Service Bulletin - Integrated Encoder

PRODUCT INVOLVED: GD, GDI and NL120Q/X series.

STARTING FROM S/N: DA00014400

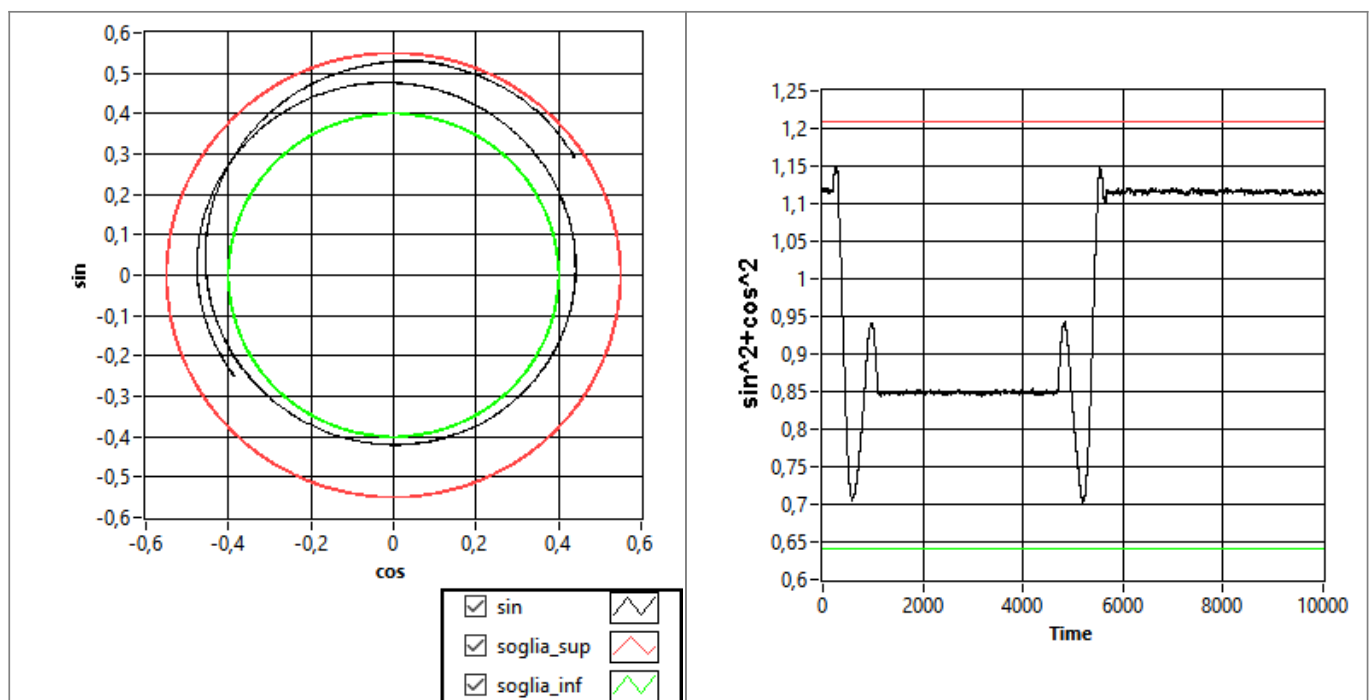
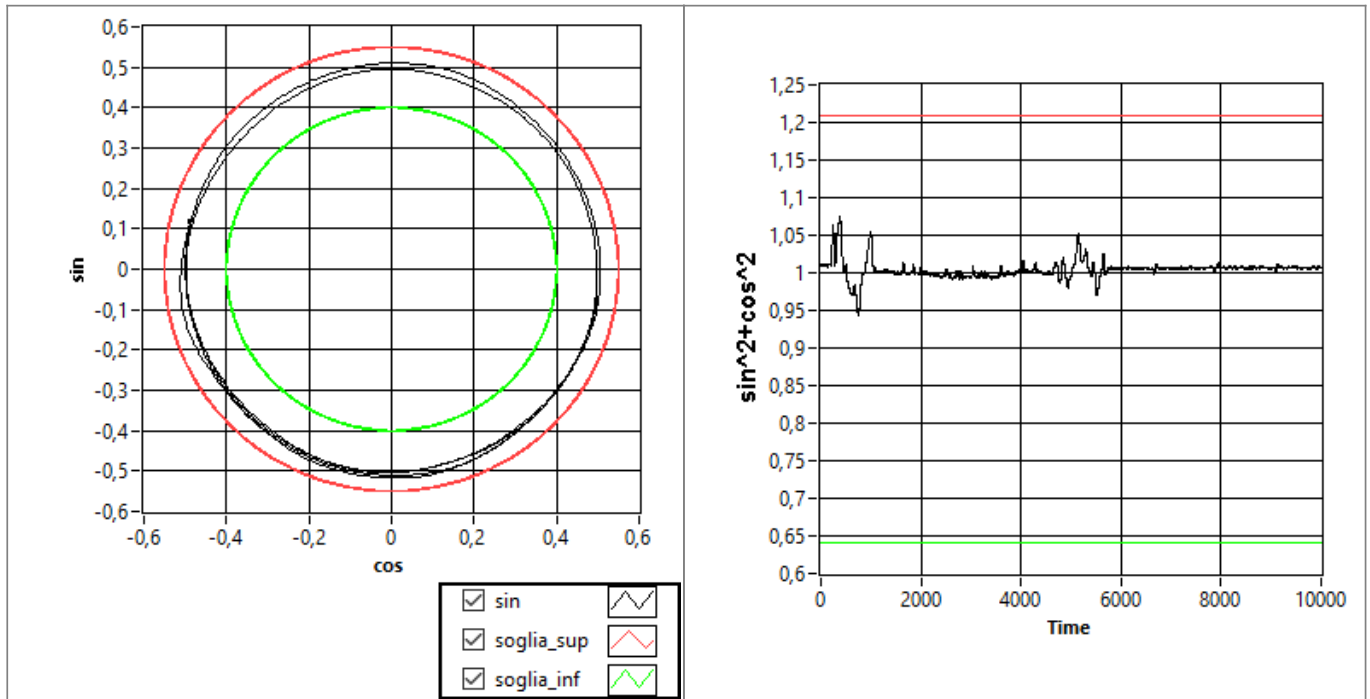
ACTION: Encoder SIN/COS Electronics changed. New signal conditioning, filtering and digital calibration.

- Protection against wrong voltage application, voltage inversion and output protections.
- Better signal quality, Offset cancellation and Peak to Peak variation reduction
- Digital Filtering

- 1) New phase angle must be calculated from the servo drive !
- 2) Possible deviation of the tuning parameters on the servo drive
- 3) Possible needs to retuning the offset and gain if a calibration on the servo drive is present.
